VIRGINIA CAST STONE
1720 HARDING AVENUE
WAYNESBORO, VIRGINIA 22980
PHONE: 540.943.9808 FAX: 540.943.0510

UNIVERSITY OF VIRGINIA
CLEMONS LIBRARY
NEWCOMB ROAD N.
CHARLOTTESVILLE, VIRGINIA

APPROVAL DRAWINGS	JOB NUMBER	SHEET NUMBER
6057	6057	2
		OF 2

APPROVAL DRAWING

3 STAIR TREAD
2 PROFILE 1 1/2"=1'-0"

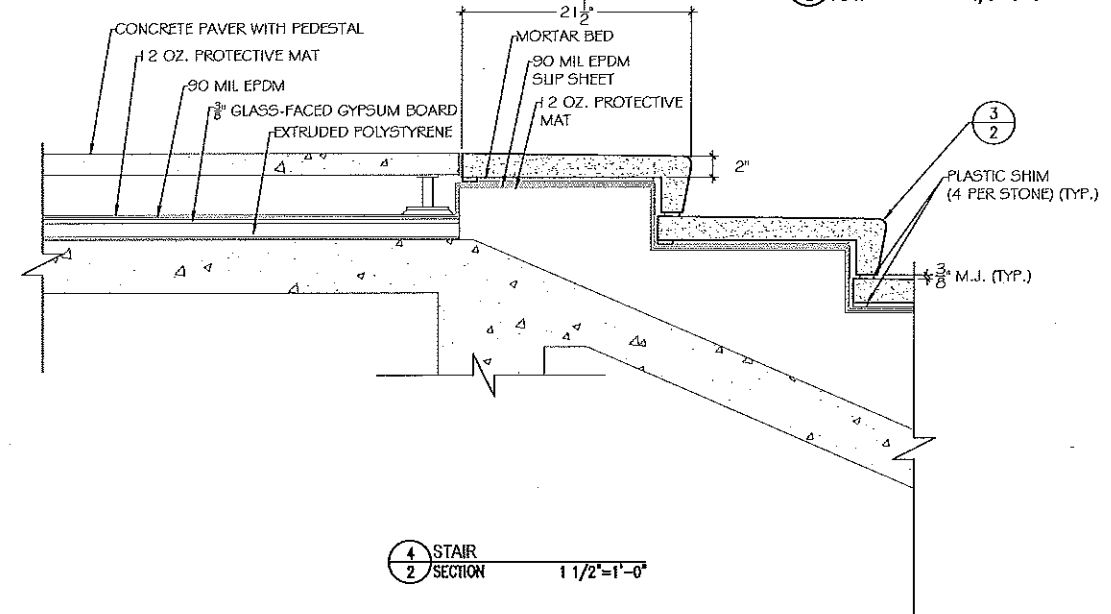
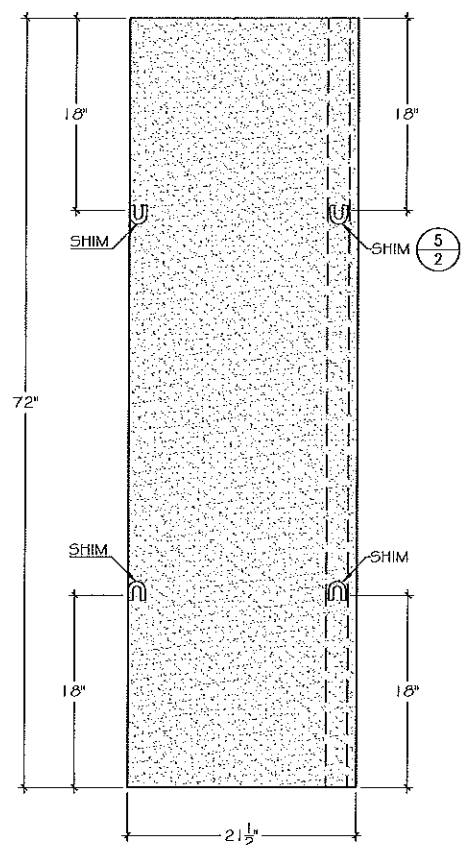
Paul
could we make the fall/slope 3/16" instead of 1/4" ?
other than that its a go.
